TITLE: BEAKS MI Peaks TH PWM Sandwich version		REV: 1.0
EasyEDA	Company: Sourcery Studios	Sheet: 1/1
	Date: 2021-07-01	Drawn By: Kristian Blå sol

V0.2

V0.3

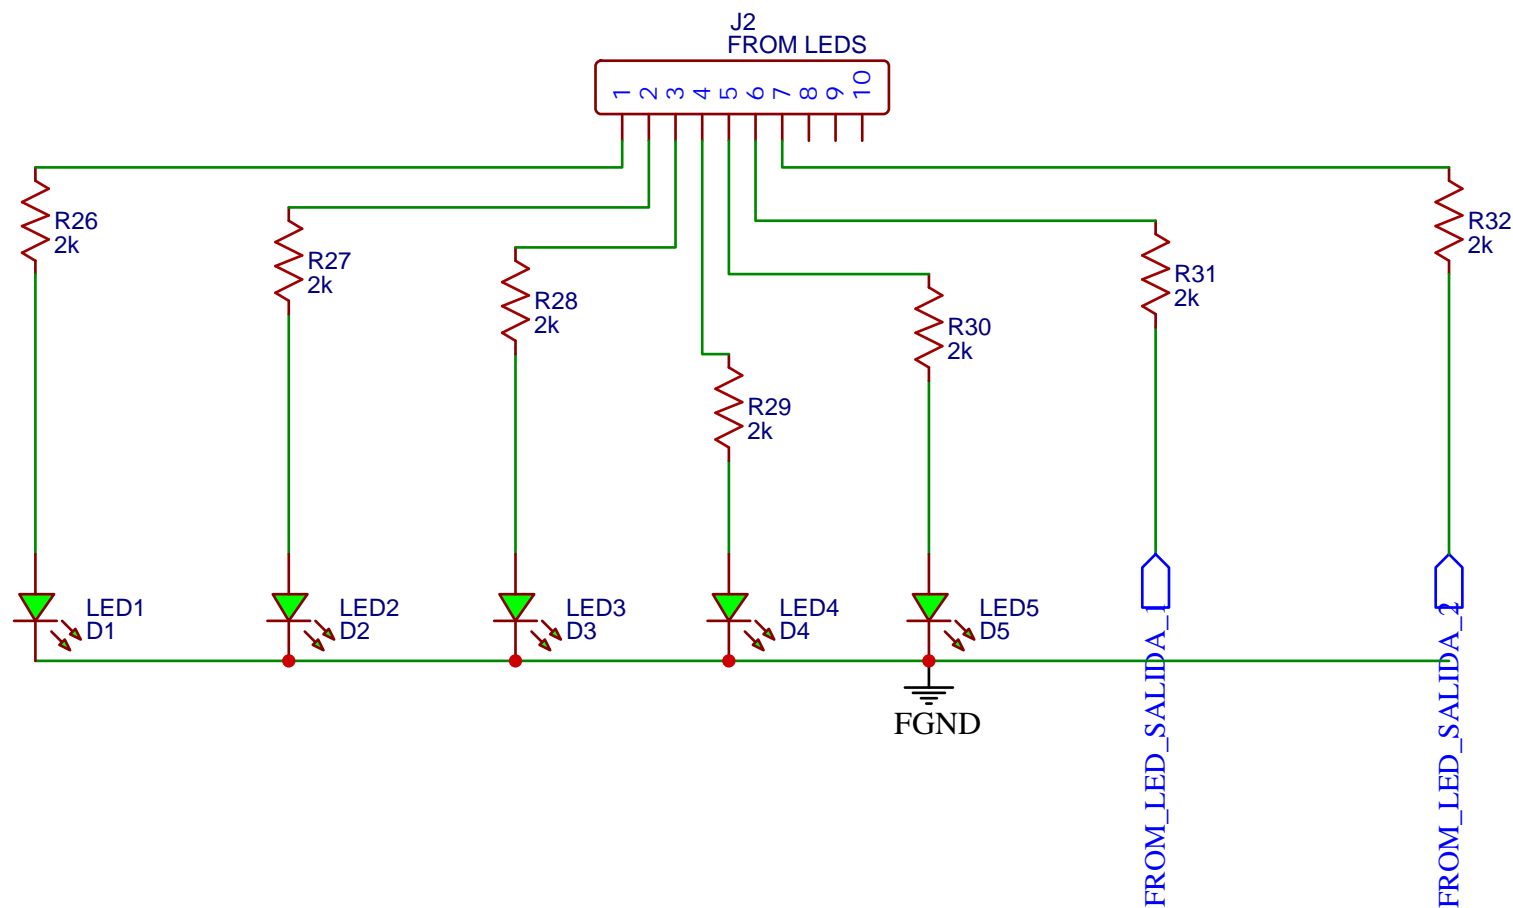
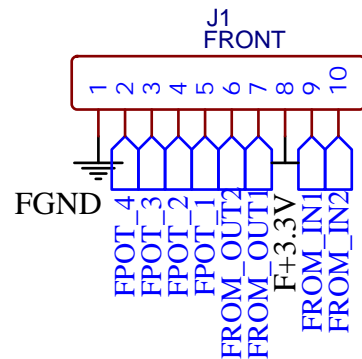
- Turned all Pots around.
- Changed all buttons which were ALL wrong.
- Bigger mode and split buttons.
- Added a stud to keep front panel in place when pushing split and mode with alps pots. C130896 stud

- Mode and split was still wrong. Changed place. DONE!
- Output 2 isnt working? U2.2 wrong orientation. DONE!
- TRIG LEDs not working wrong orientation? DONE!

Ändrat C10 fr 033 till 10u

TITLE: BEAKS MI Peaks TH PWM Sandwich version		REV: 1.0
EasyEDA	Company: Sourcery Studios	Sheet: 1/1
	Date: 2021-10-19	Drawn By: Kristian Blå sol

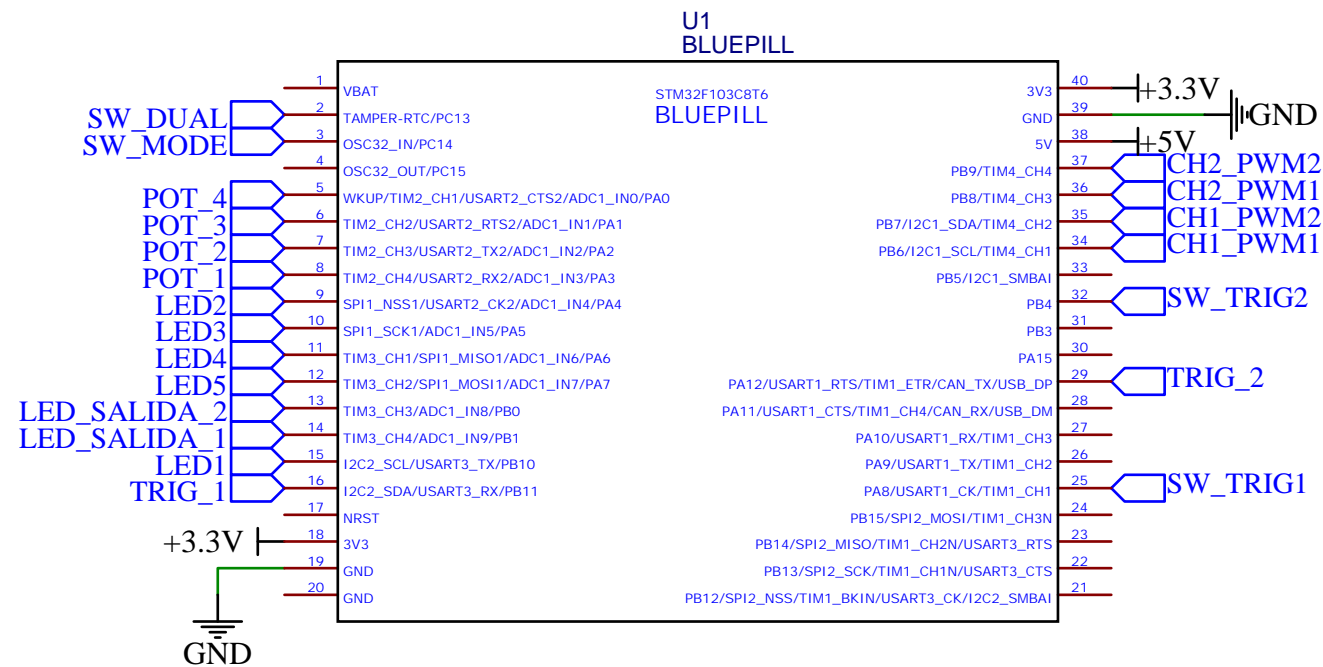
221219 sleeve to ring connection?
Its on the original schem so have it
(but mono jacks ofcourse)
